Addendum No. 1

Project: Expand Long-Term Parking & Realign Terminal Exit Road (Ross Drive)
FWACAA Project No. AF25-01

Date: June 20, 2025

C5.3.1

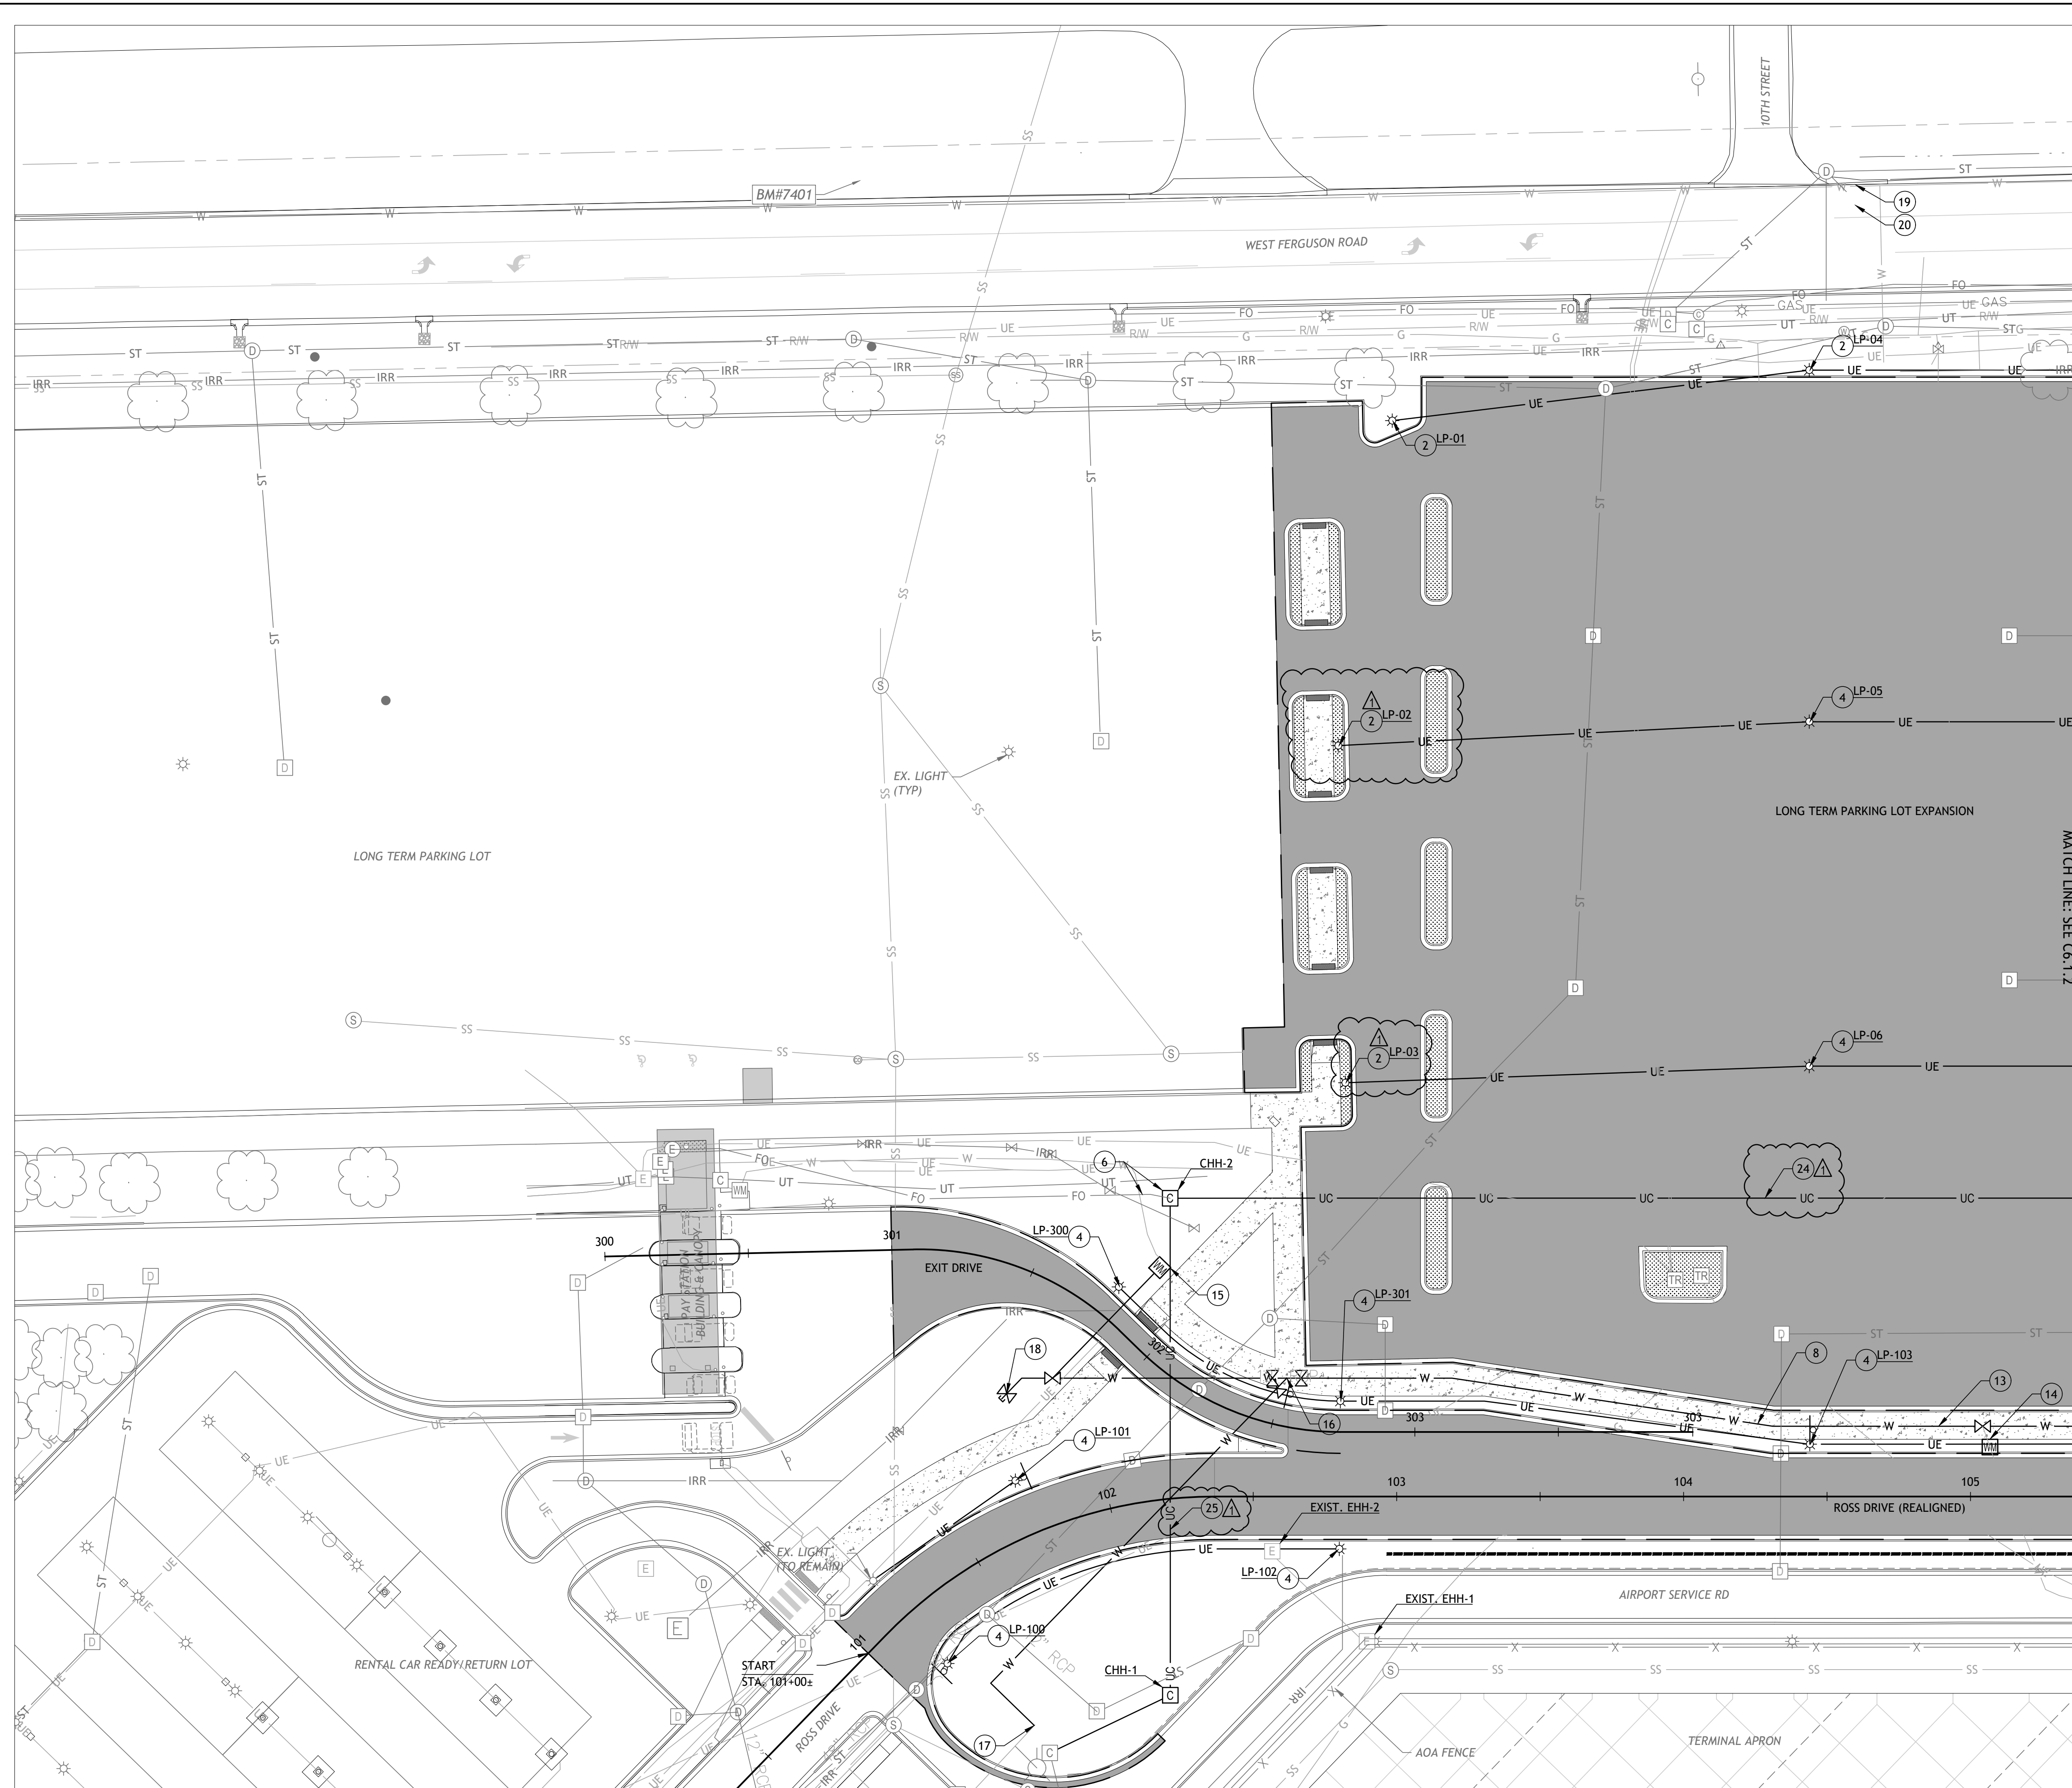
Reissued: Sheet reissued to clarify (and separate) new storm sewer structures and those that are existing but will require adjustment to finished grade.

U1.1.2

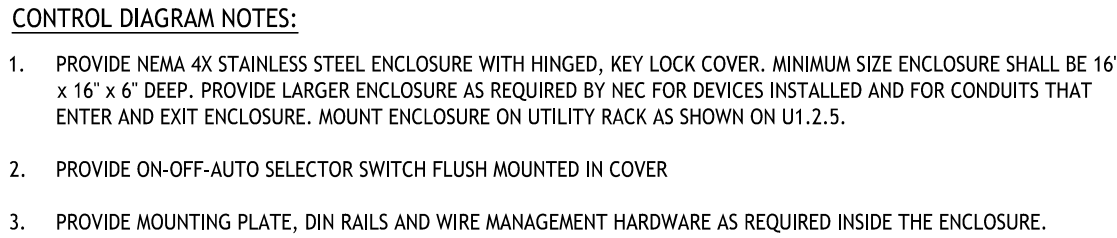
- Adjusted underground electrical conduit/wiring to be connected to sign S-100 and S-200 for power. Additional wiring changes were made to accommodate the new layout.
- Added Key Note 6 callouts in plan view for new conduit and fiber optic cable installation.
- Utility & Electrical Plan Key Notes 6 and 18 revisions.
- New Utility & Electrical Plan Key Notes 21 thru 25 added.
- New Fire Hydrant Type III Modified installation near Sta. 106+00, 17.5' L Line RD-1 and Sta. 109+90, 35' L Line RD-1.
- Other miscellaneous revisions as shown
